PC/104
Specification, Version 2.1

V2.2 is an update of V2.1 with a revision note regarding the interrupt-sharing option

PLEASE NOTE - CORRECTION to PC/104 Specification, Version 2.1

Typical Interrupt-Sharing Circuit

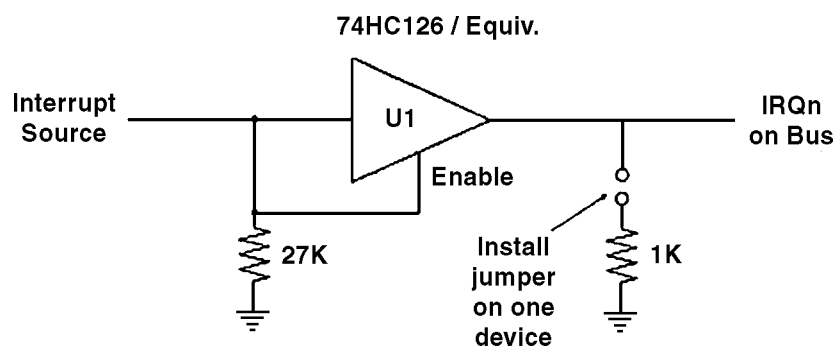
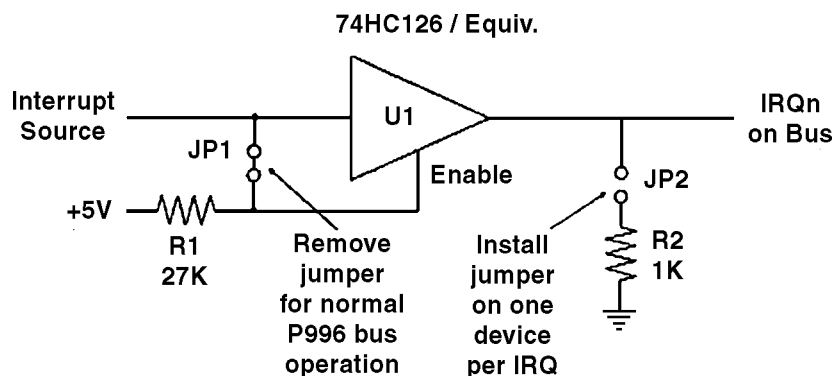
Please note the follow **change** which must be made to the page entitled

“**Appendix C - Interrupt-Sharing Option**” (next to last page in specification booklet):

The schematic shown (Typical Intenupt-Sharing Circuit) is incorrect. The **correct drawing, which appeared in PC/104 Specification, Version 1, should be inserted in its place.** A copy of the correct schematic follows.

Please **paste** this drawing into your copy of the 2.1 Specifications and **change the title** on the front cover to read “**PC/104 Specification, Version 2.2.**” Please accept our apologies for the error. Thank you.
